**Aumsville, Oregon  
Wastewater Treatment Plant Improvements  
ADDENDUM NO. 3**

**OWNER:**      **The City of Aumsville, Oregon**

**FROM:**       Westech Engineering, Inc.

**DATE:**        **July 10, 2026**

DRAWING  
**S010**  
28 OF 223  
JOB NUMBER  
**231048**

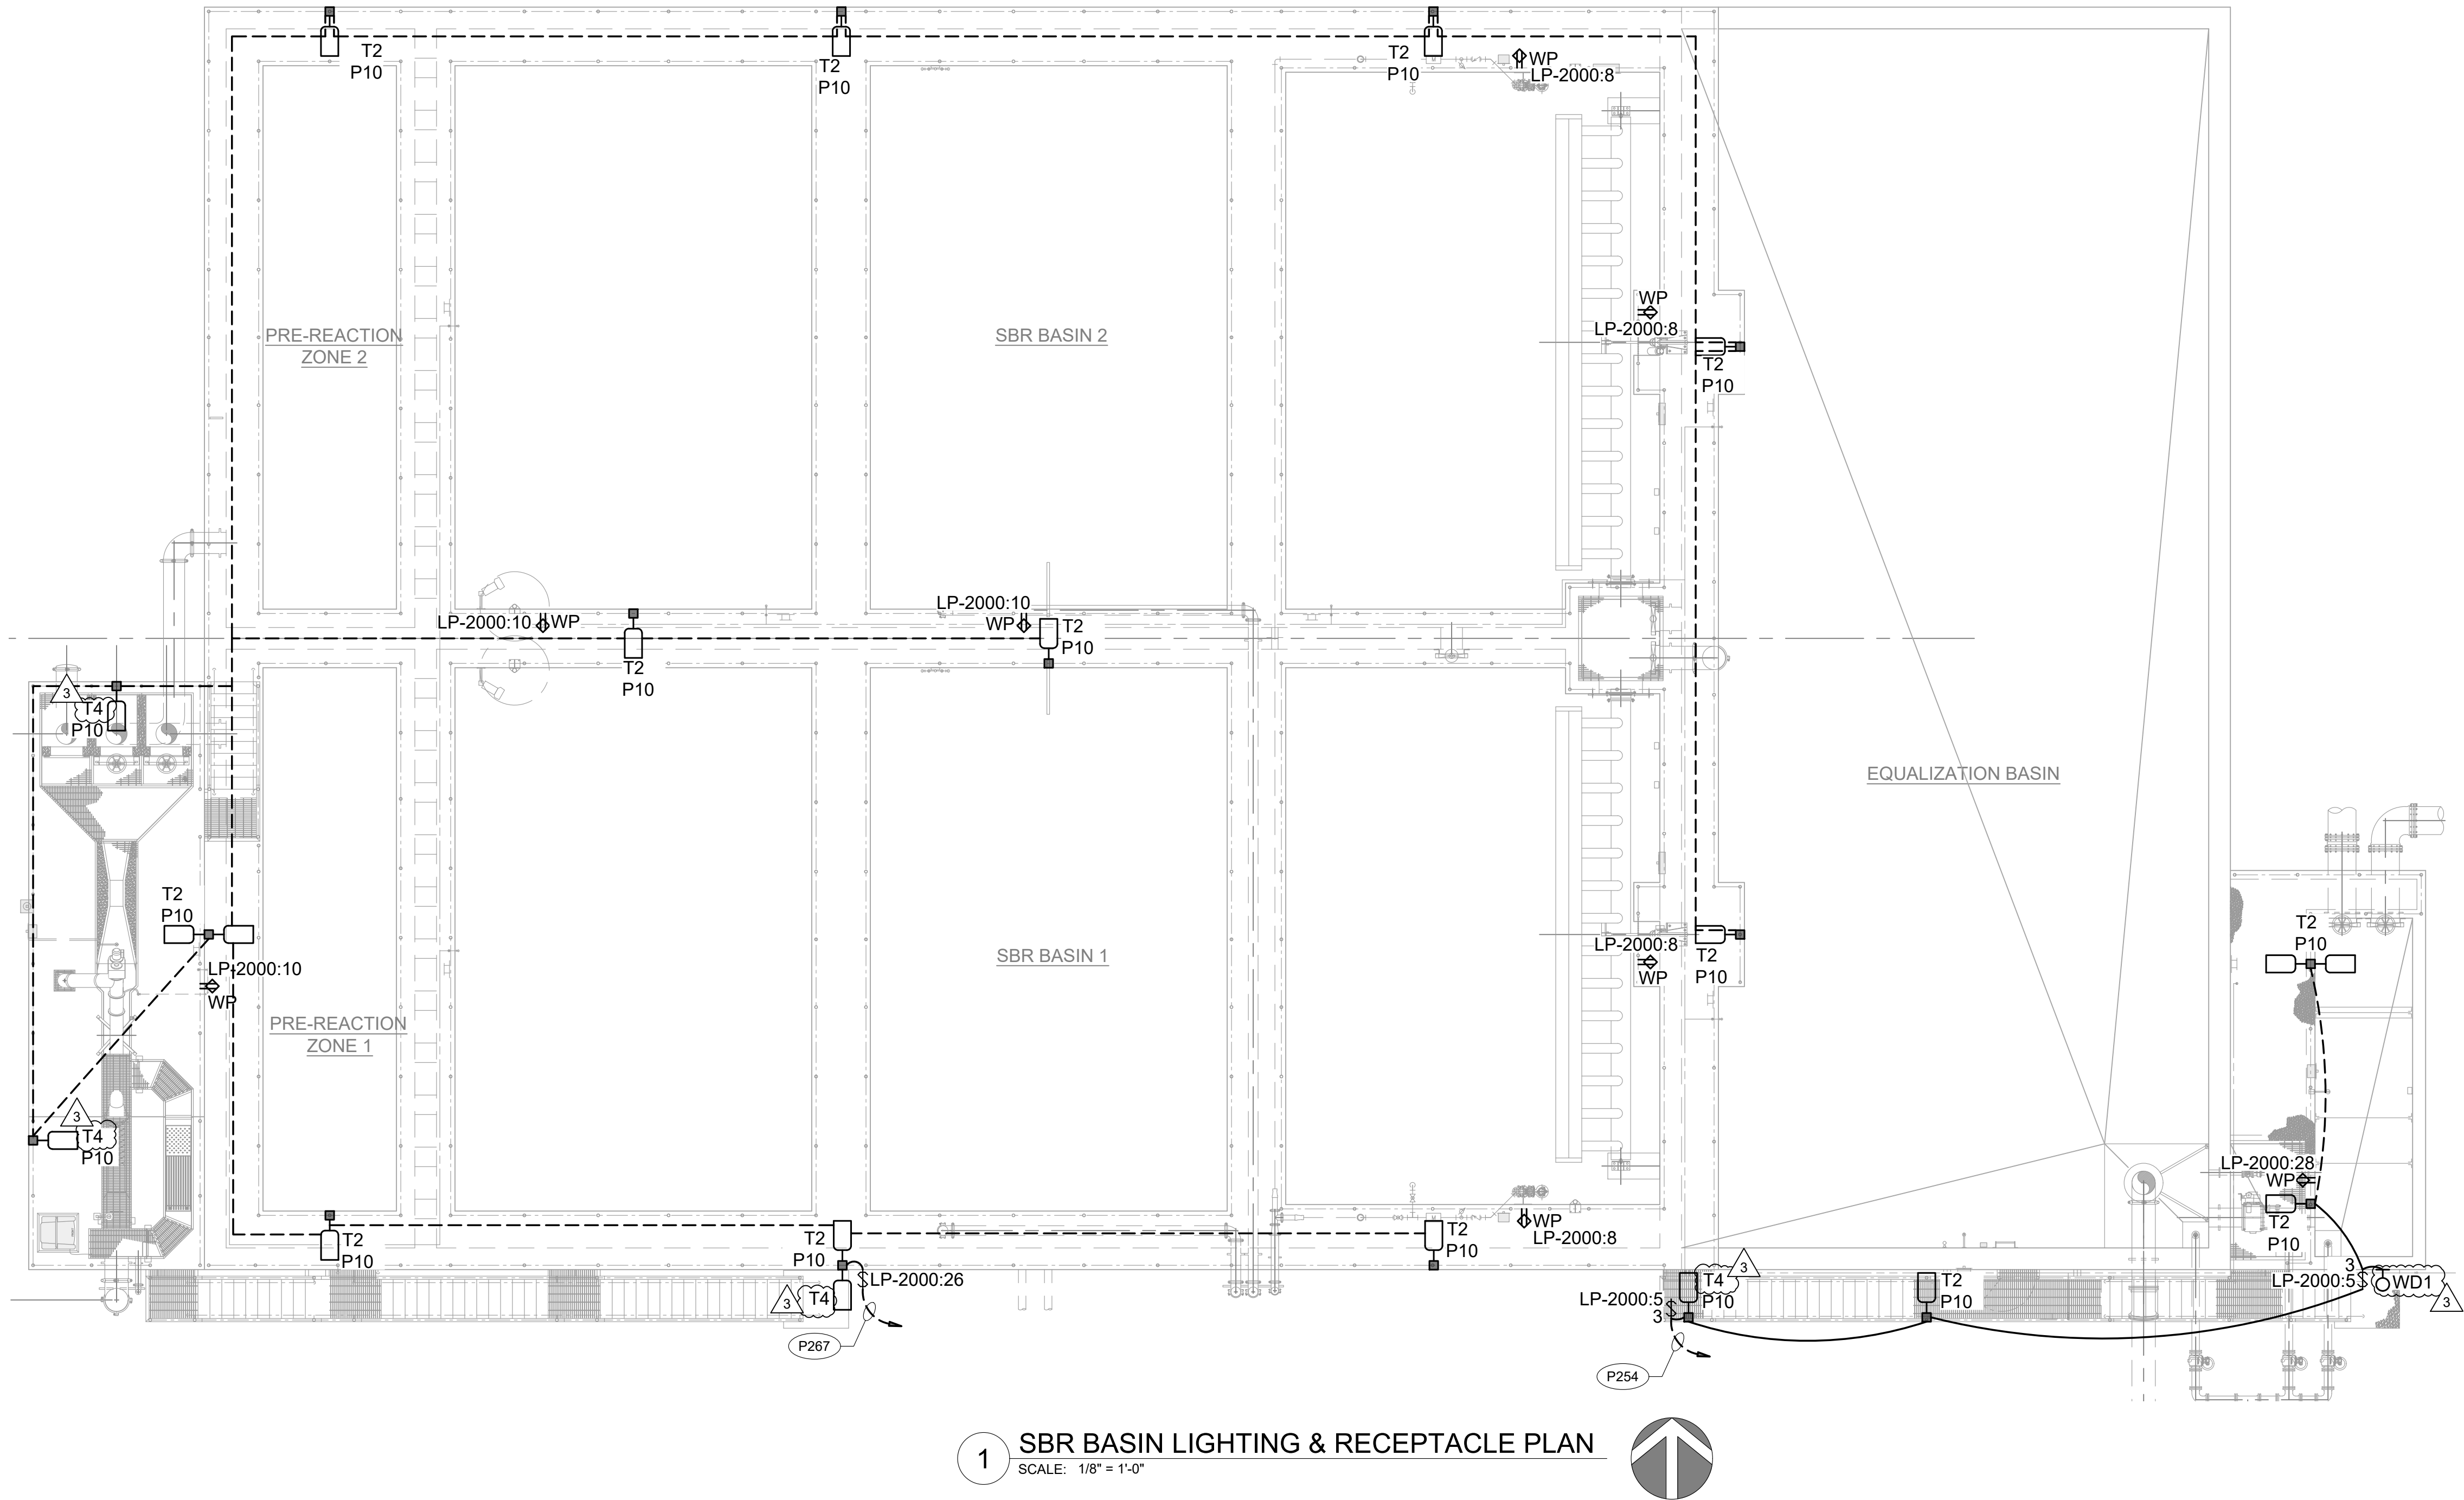
14. Drawing S010, (Typical Metal Details).

- a. Delete this sheet entirely and replace with the revised drawing S010 attached hereto. Detail 2/S010 has been revised. There were some incorrect reference to stainless steel grating supports that have been changed to aluminum. The intent of the plans is for all of the grating support members to be aluminum.

DRAWING  
**E212**  
174 OF 223  
JOB NUMBER  
**2599.3220.0**

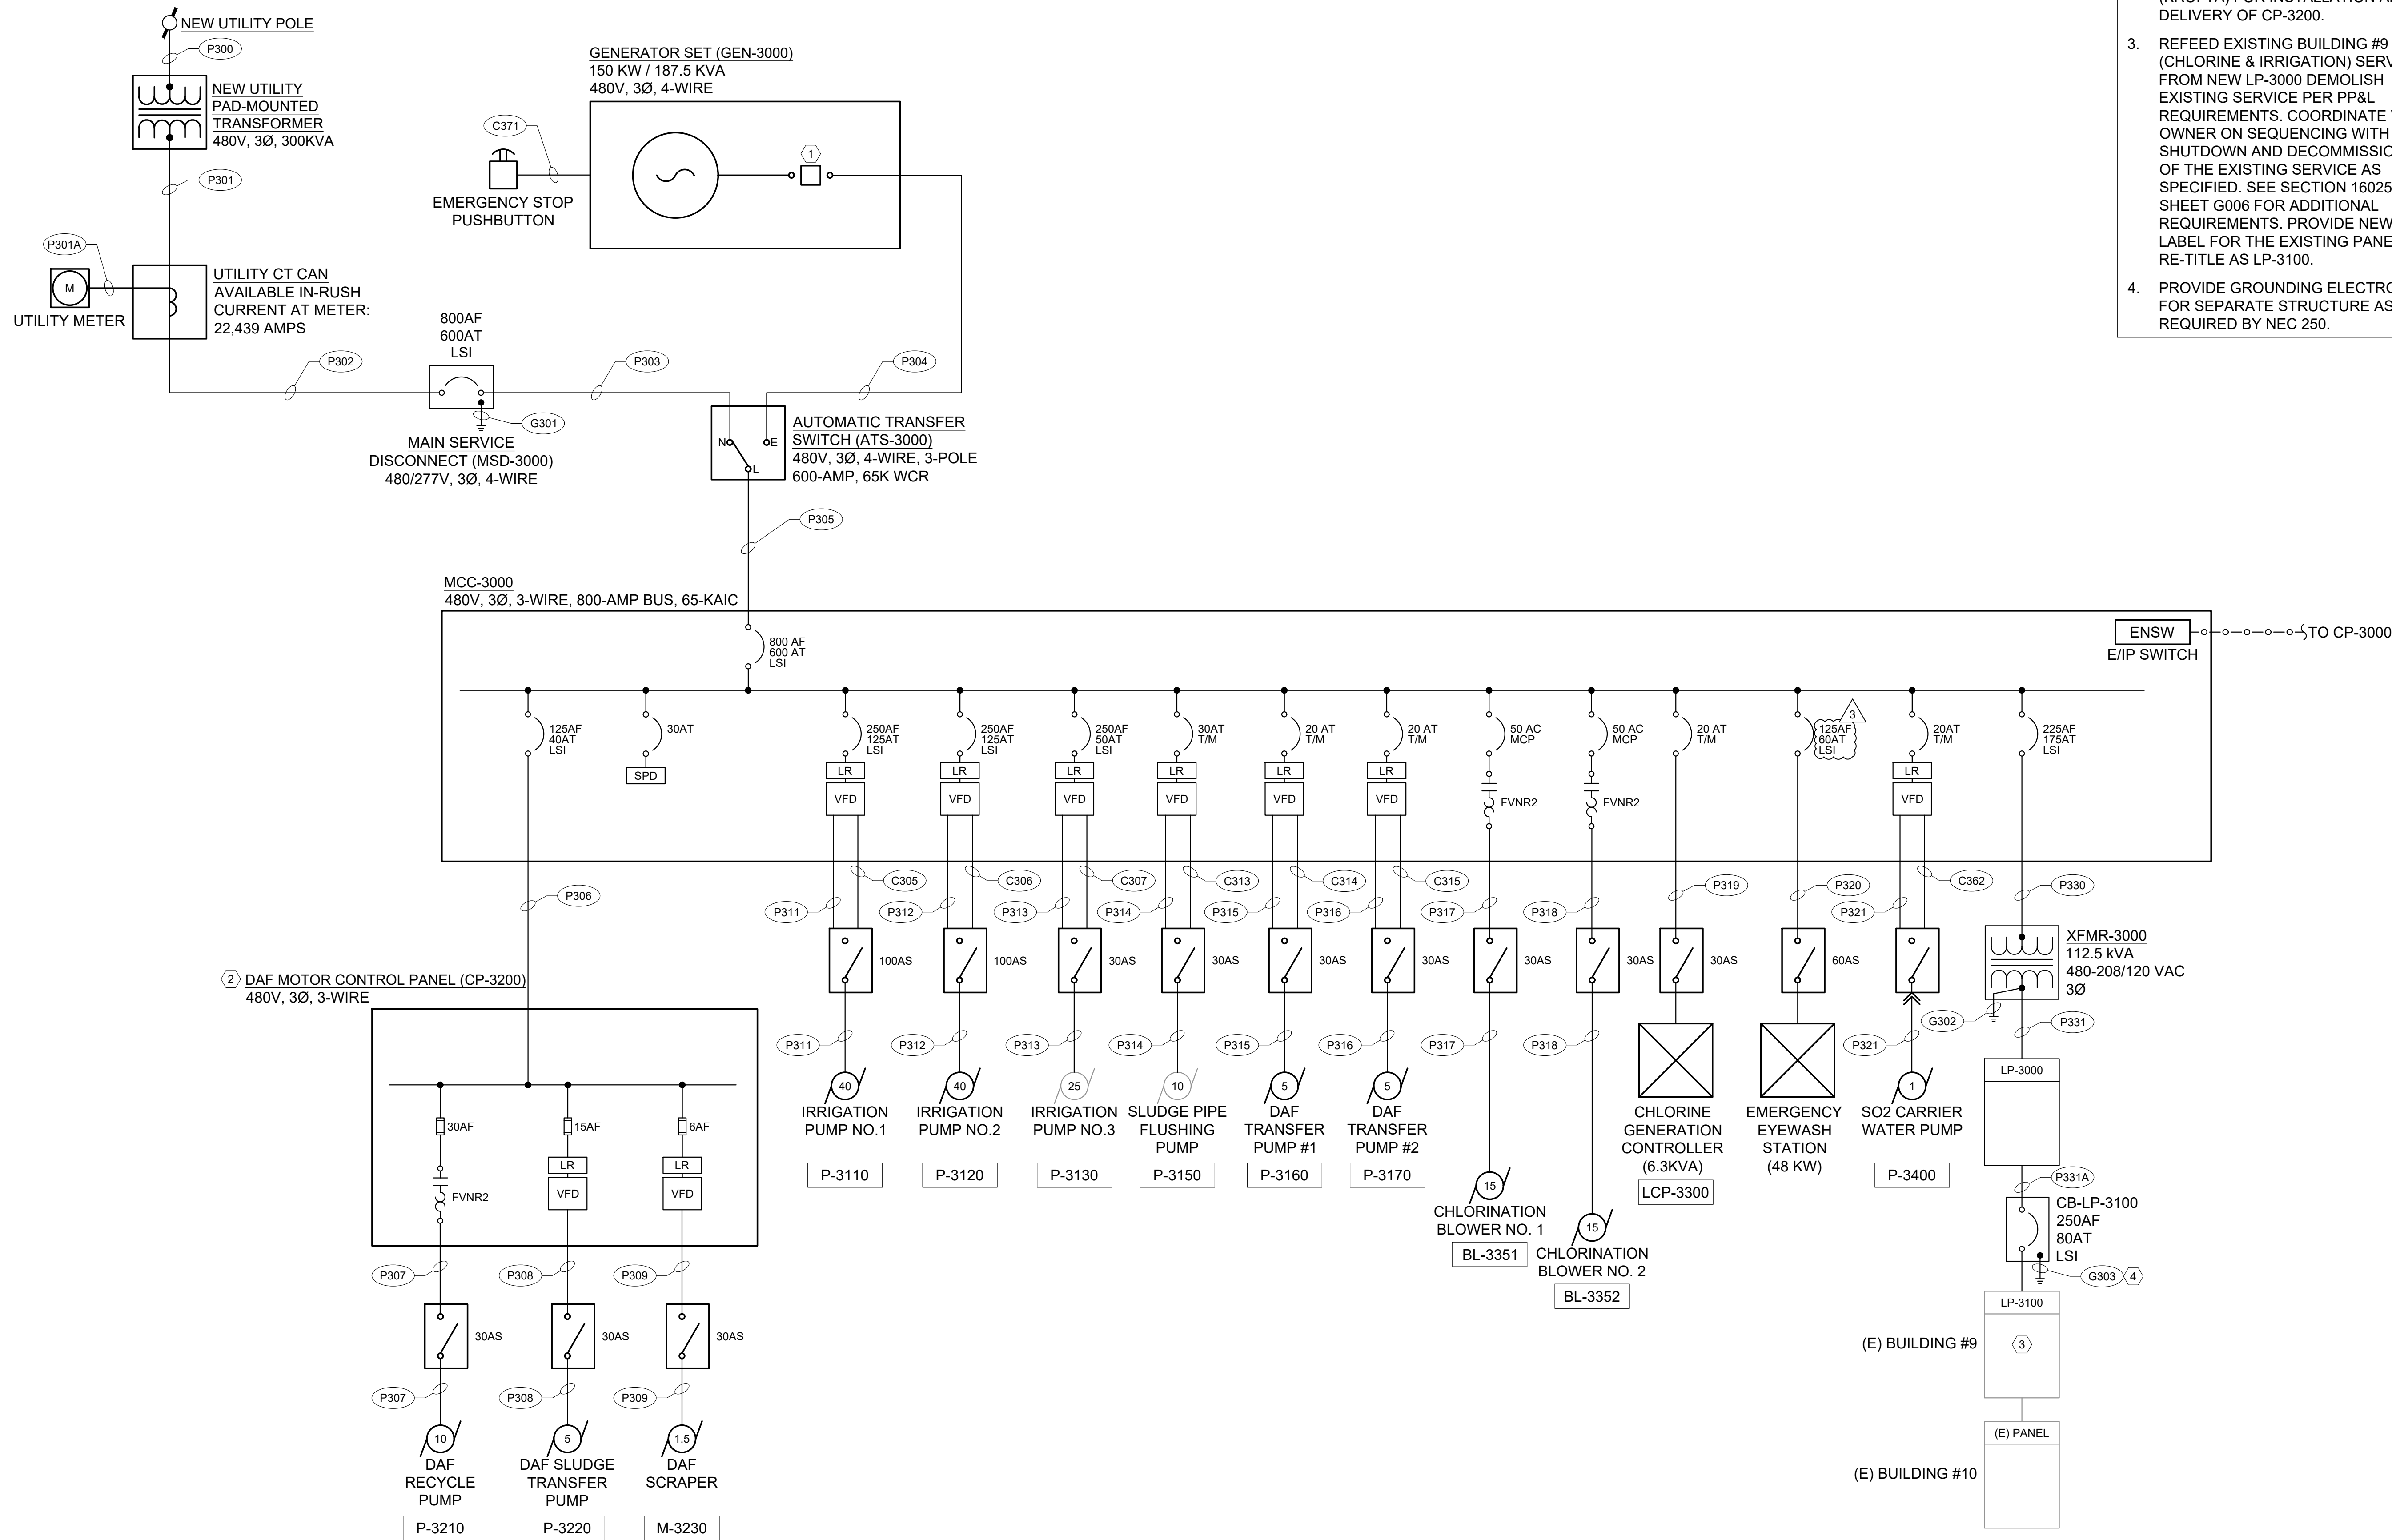
18. Drawing E212 (SBR Basin Lighting & Receptacle Plan)
  - a. Delete this sheet entirely and replace with the revised drawing E212 attached hereto. Revised light fixture tag from T2 to T4. Added WD1 tag to light fixture.

DRAWING  
E300  
185 OF 22  
JOB NUMBER  
2599.3220.

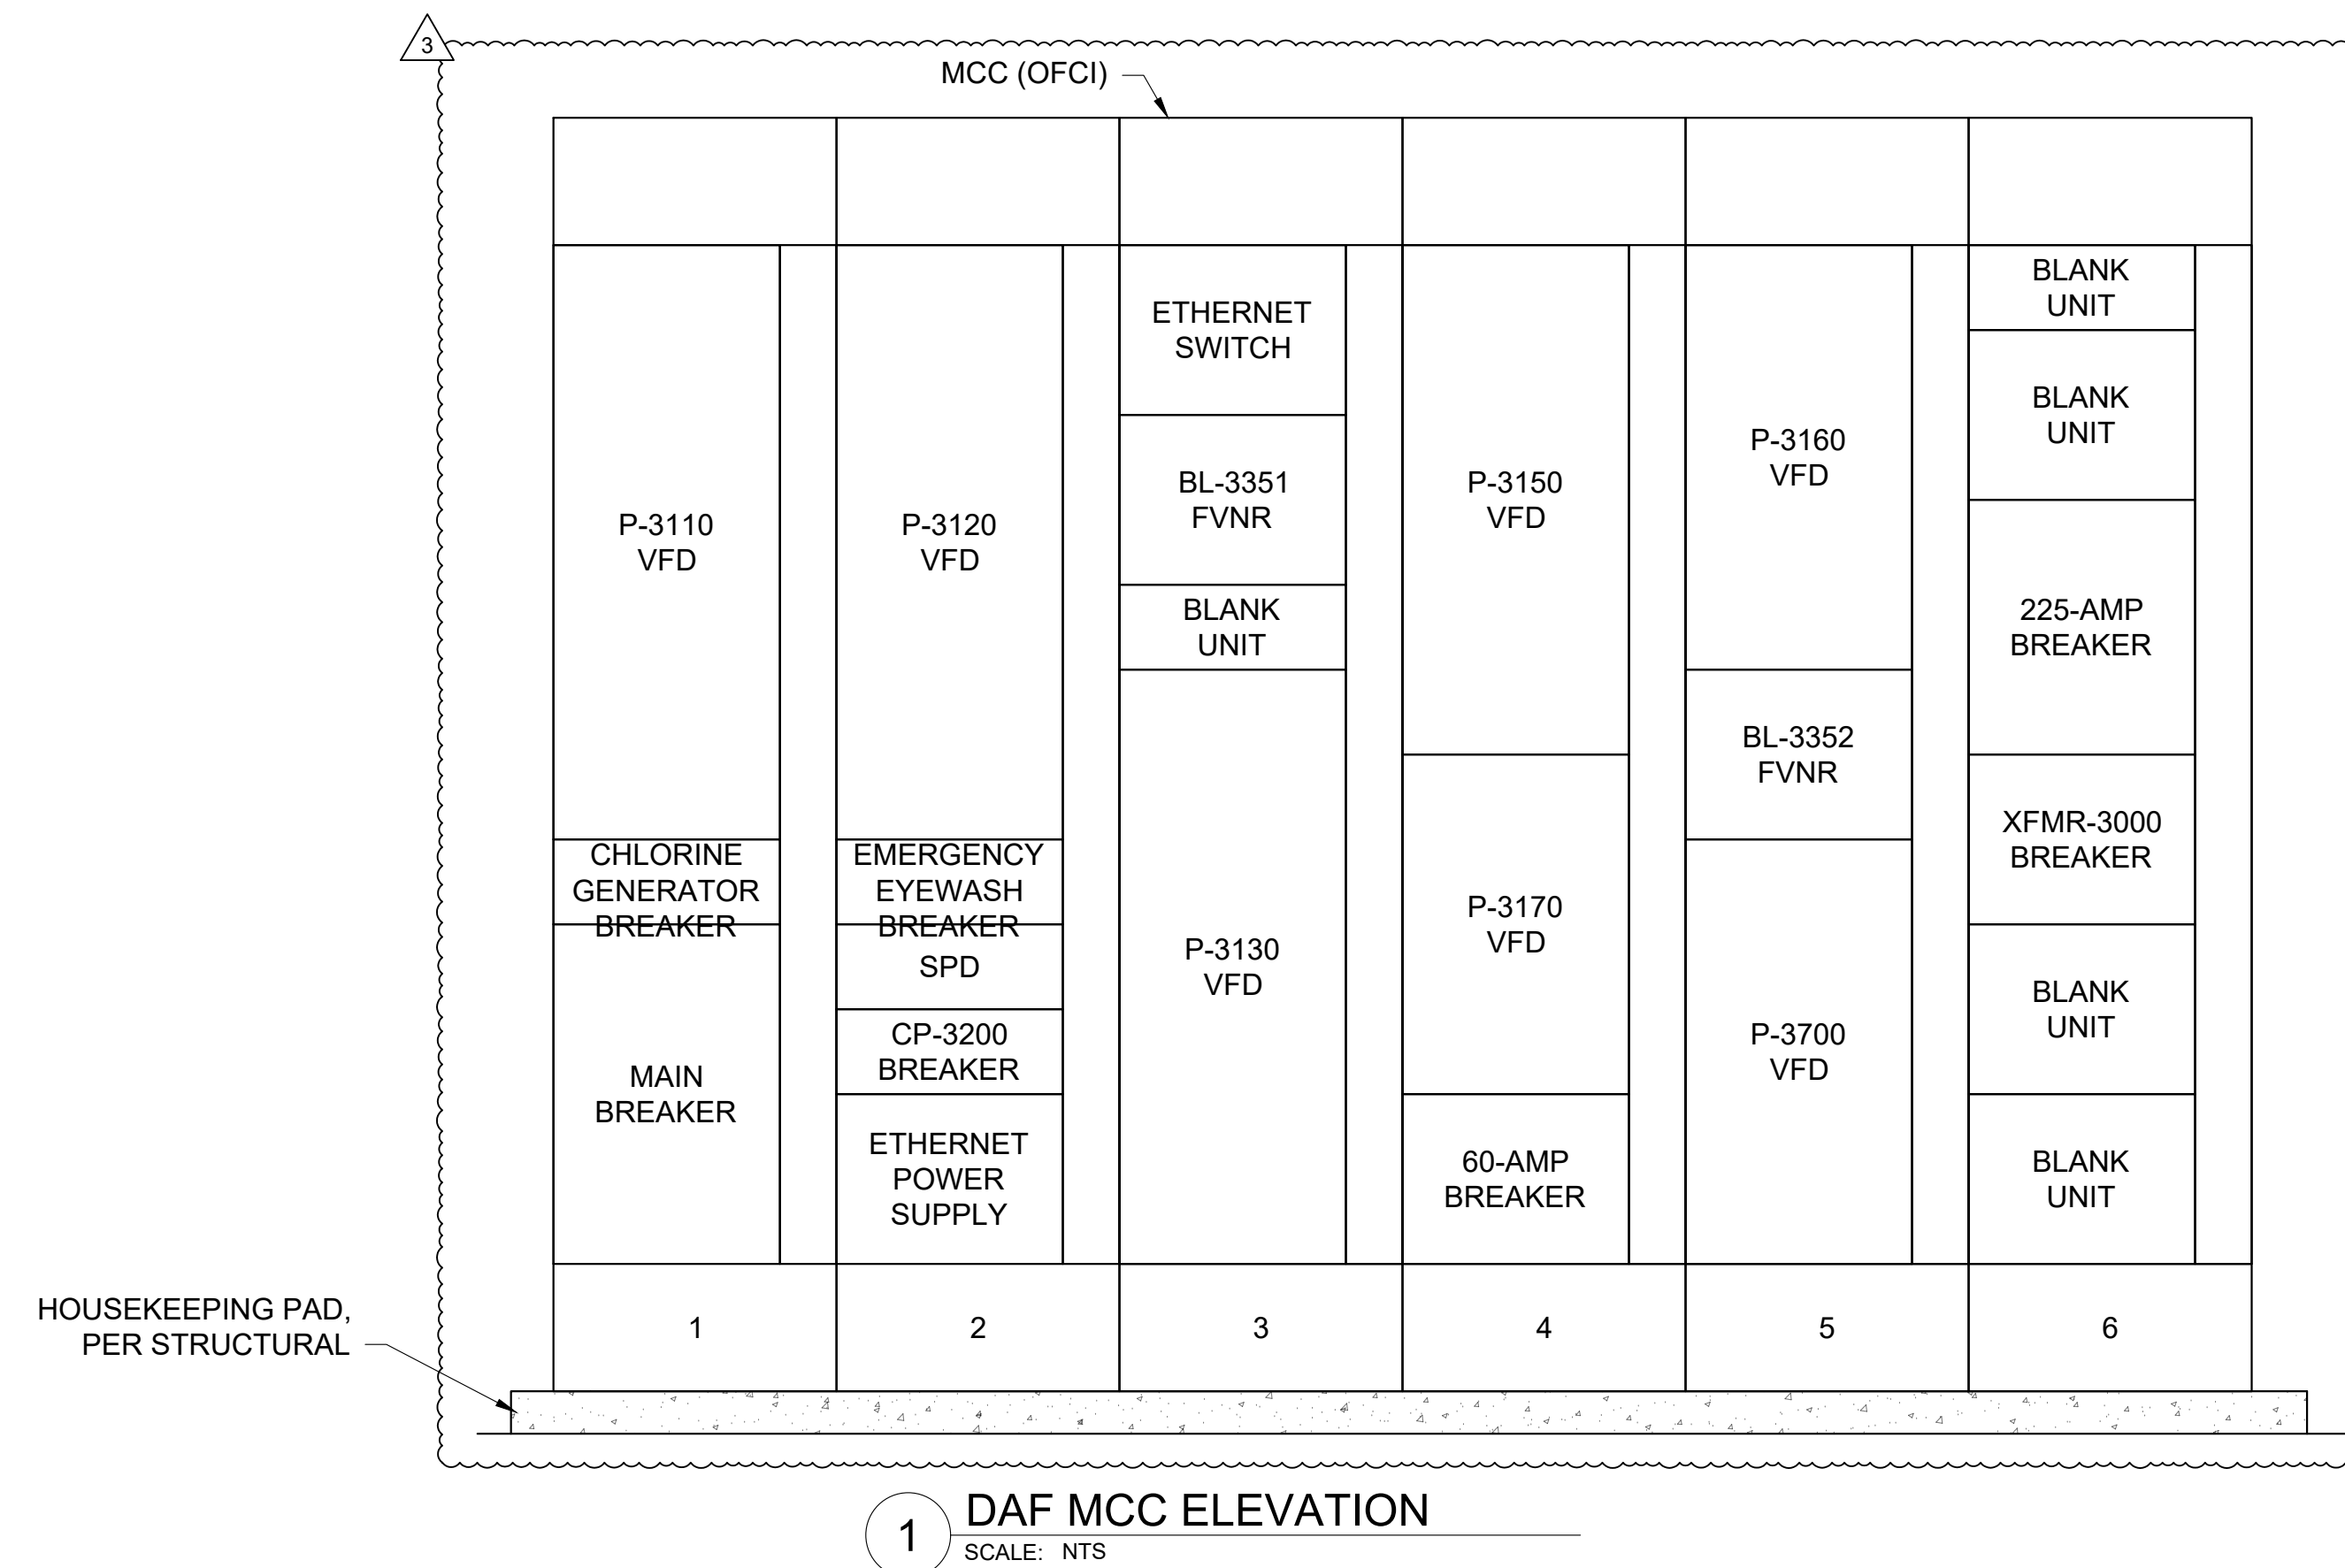
19. Drawing E300 (DAF Building One-Line Diagram)
  - a. Delete this sheet entirely and replace with the revised drawing E300 attached hereto. Revised breaker trip rating.
